## ADDENDUM NO. 1

### San Antonio Water System

Project Name: **Olmos Basin Central Watershed Sewer Relief Line (C-3), Reaches 1 to 4**

Project No.: **08-2512**

SHEET NO. C-107  
 20 OF 123

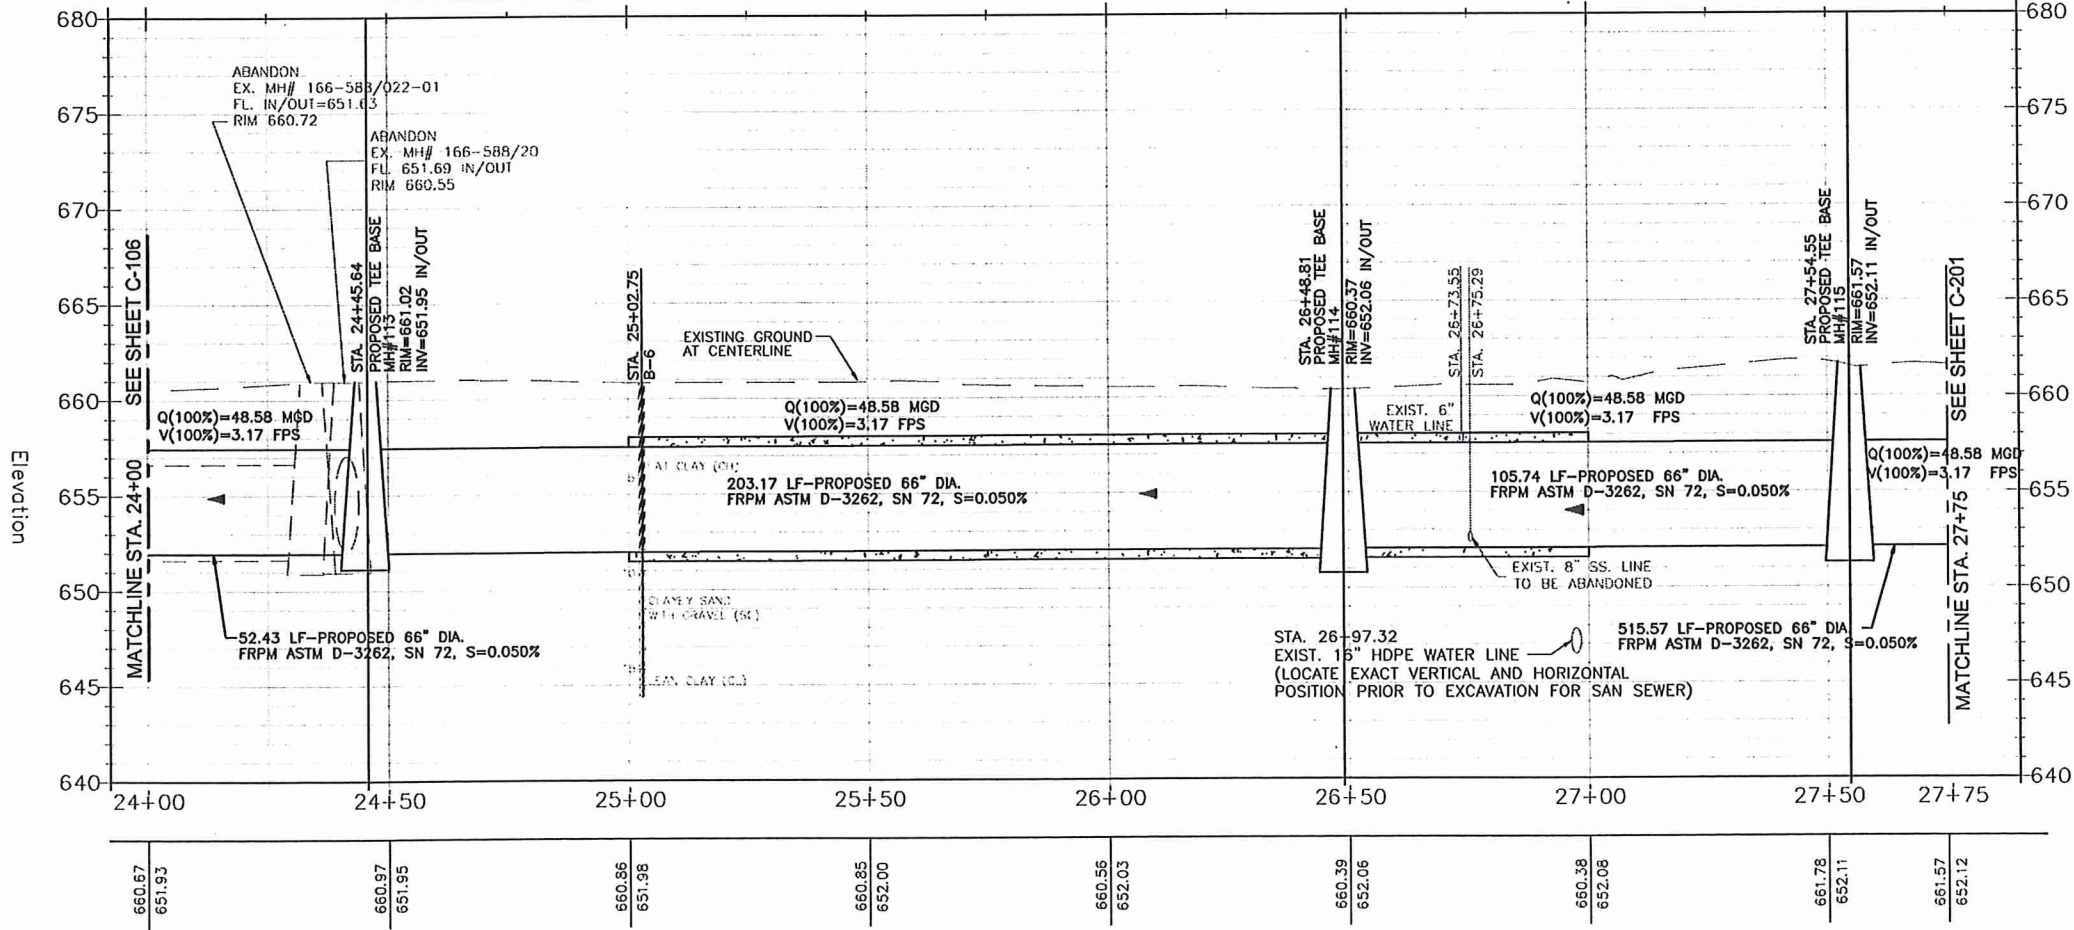
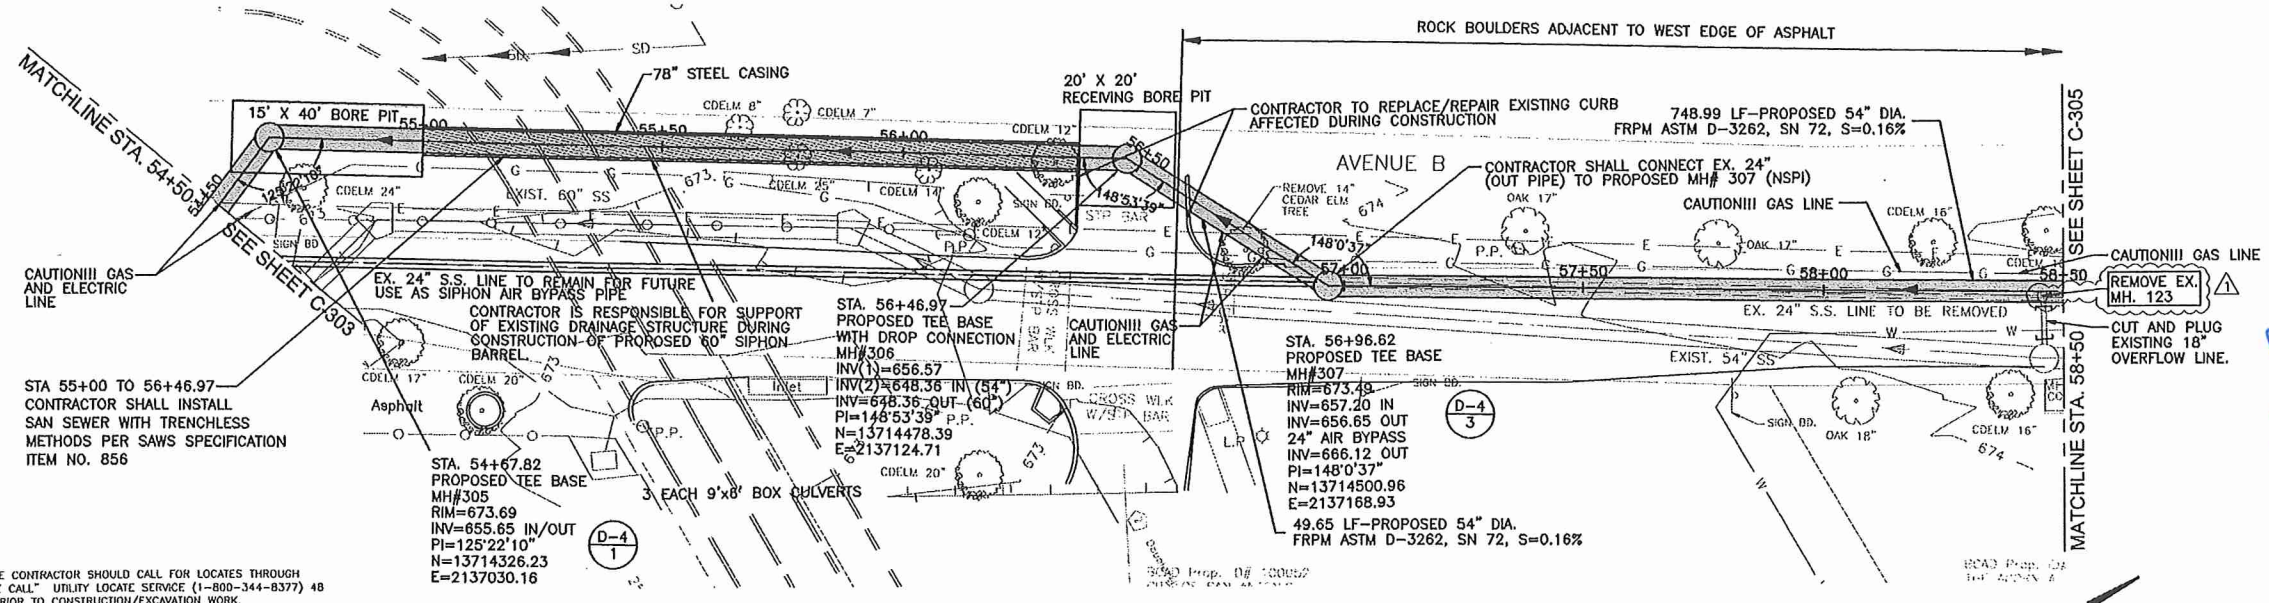
**Q15: On Plan Sheet C-107, Sta. 26+10, we are assuming the existing 4" pipe material for the WW Service line is PVC SDR 35. We are also assuming this is a gravity line. Is this correct?**

**Q16: On Plan Sheet C-107, Sta. 26+73, Contractor is to relocate an existing 6" potable water line. We are assuming the 6" pipe material is asbestos cement. Is this correct?**

*Existing service connections shall be confirmed by Contractor (number, location, size, material, elevations). Refer to San Antonio Water System Standard Specifications for Construction, Item No. 854, Sanitary Sewer Laterals and Item No. 1109, Sanitary Sewer Service, Stubs or Reconnections. The existing service line at MH# 166-588/018-01 is a gravity sewer lateral.*

*Existing service connections shall be confirmed by Contractor (number, location, size, material, elevations).*

NOTES	INITIALS	DATE																	
DESIGNED BY	AH	01/27/12																	
REVIEWED BY	MRJ	01/27/12																	
SCALE:	AS SHOWN																		
SHEET NO.	<b>C-304</b>																		
	29 OF 123

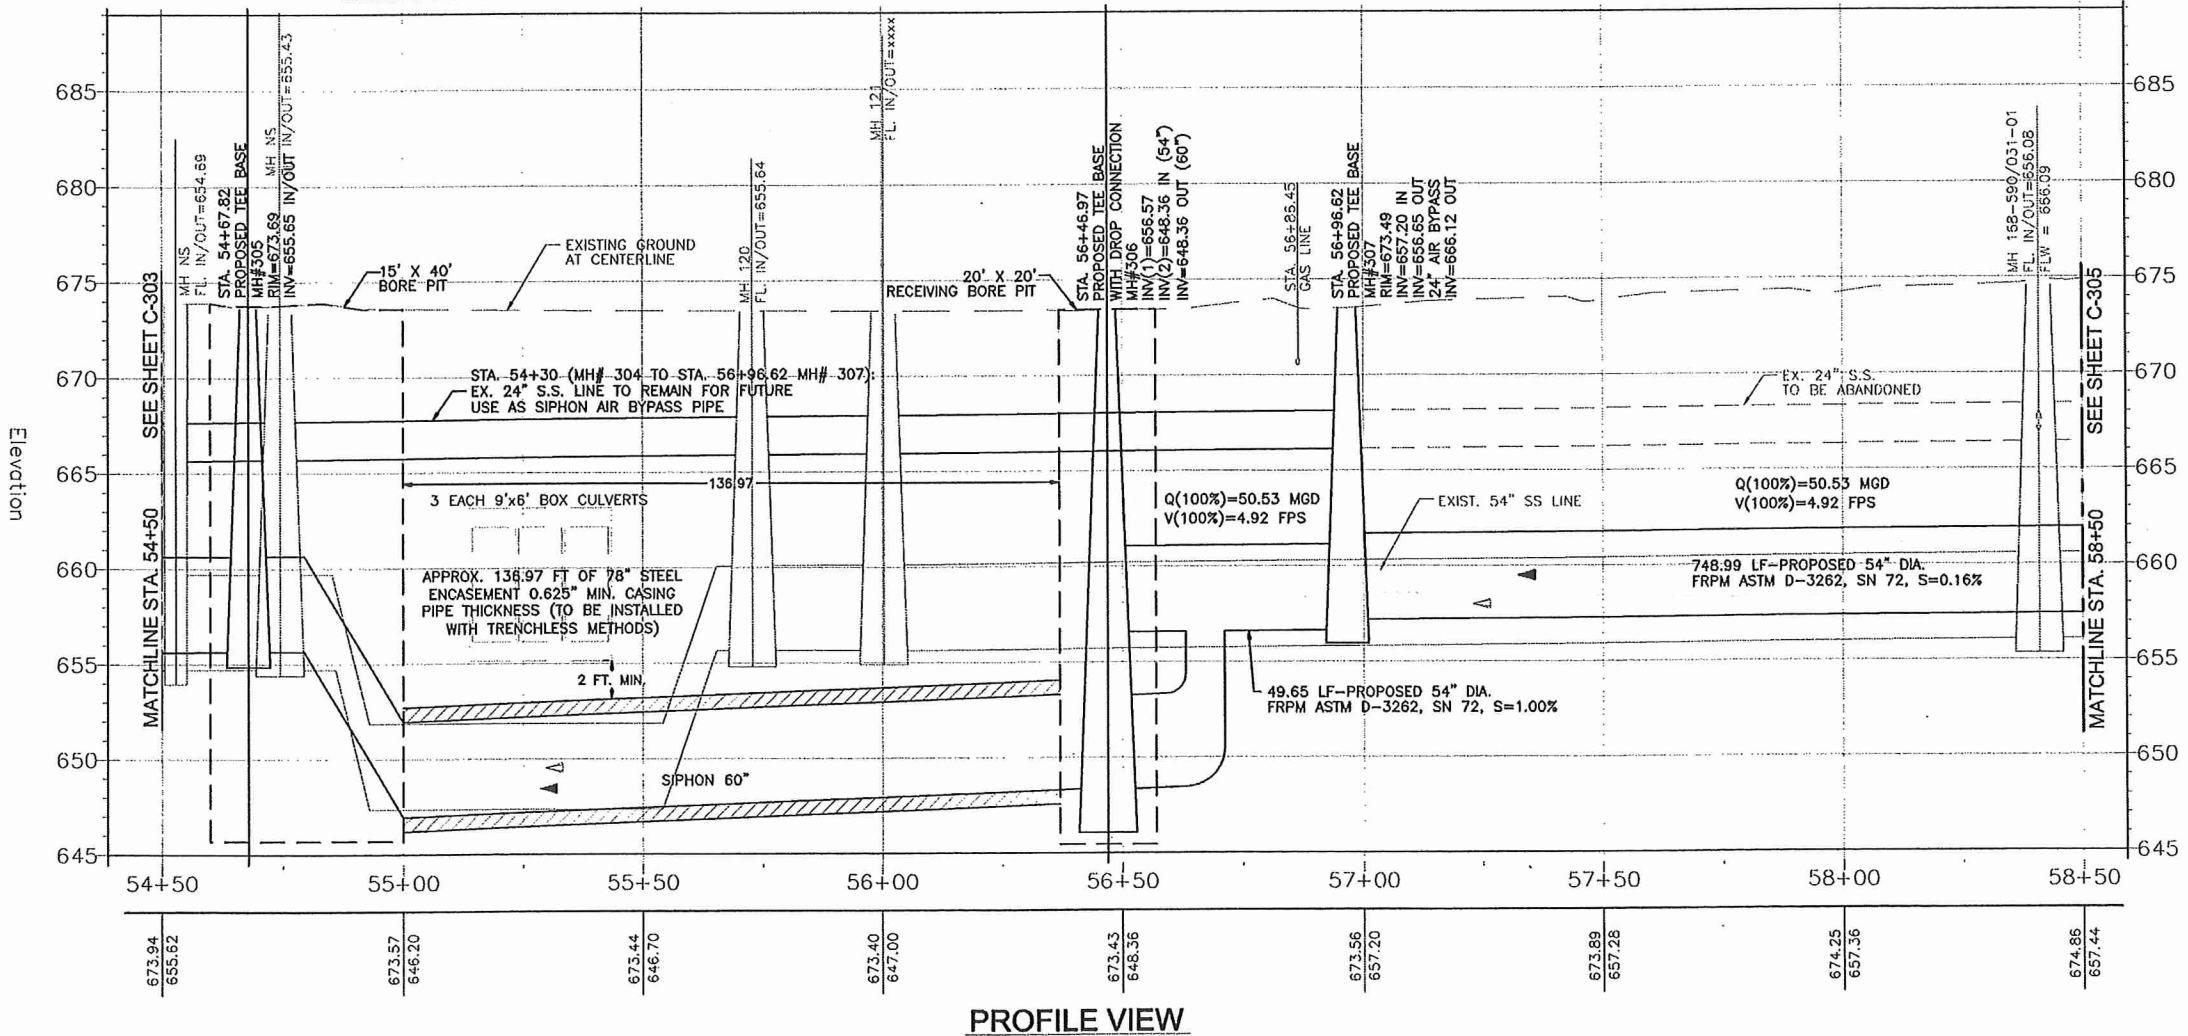
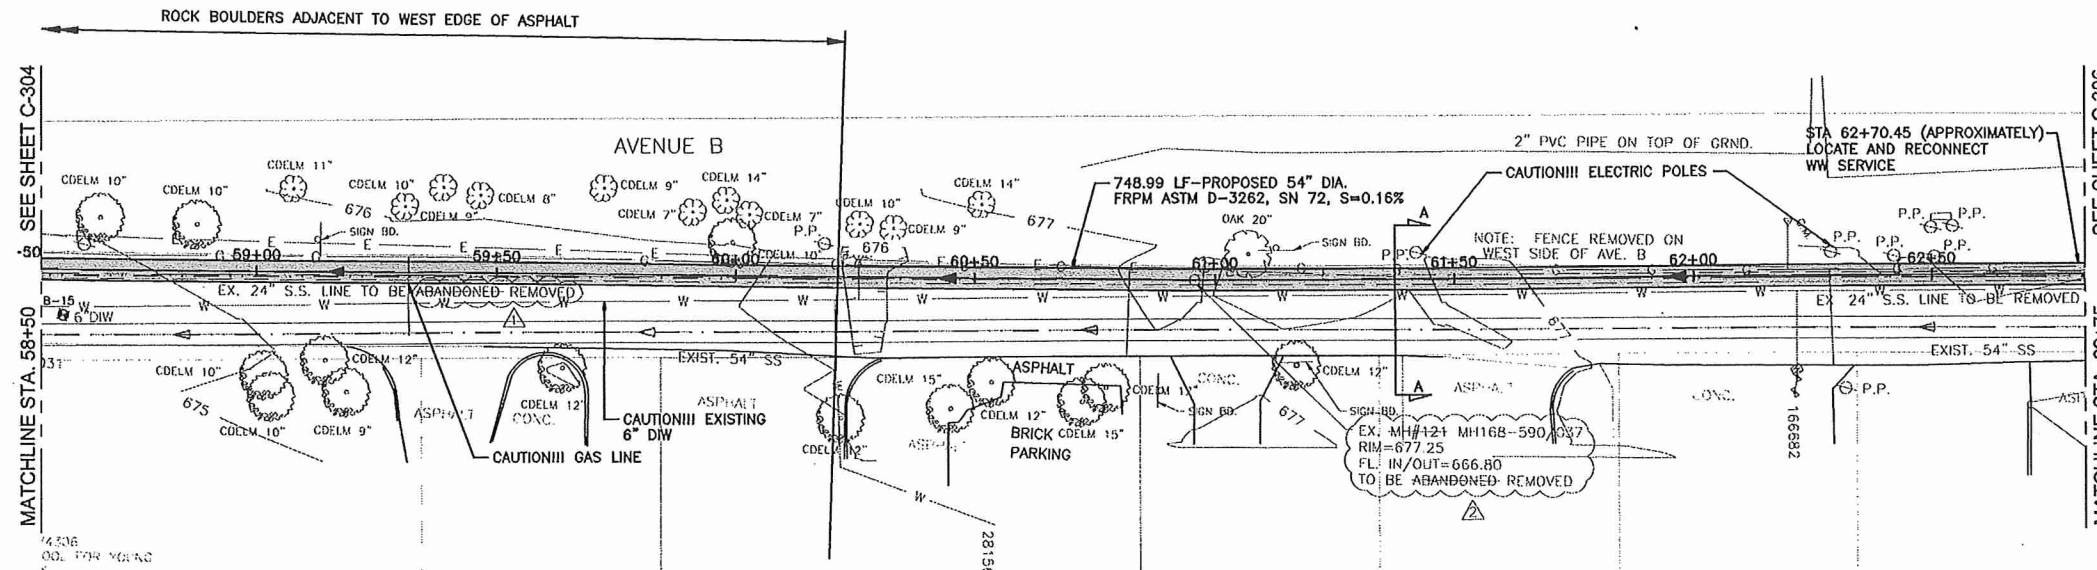
**Q17: On Plan Sheets C-304 thru C-307, Sta. 58+00 – 70+50, Contractor is instructed to protect and support an existing 6" potable water line during trenching and construction of the 54" Sanitary Sewer Main. What is the working pressure class of this existing 6" Ductile Iron Pipe? What type of aggregate material is the 6" pipe bedded in and what are the dimensions of its bedding envelope?**

*Working pressure class may be obtained from the as-built records. Contractors may obtain SAWS as-builts from SAWS Counter Services. Bedding materials and dimensions will need to be field verified by Contractor.*
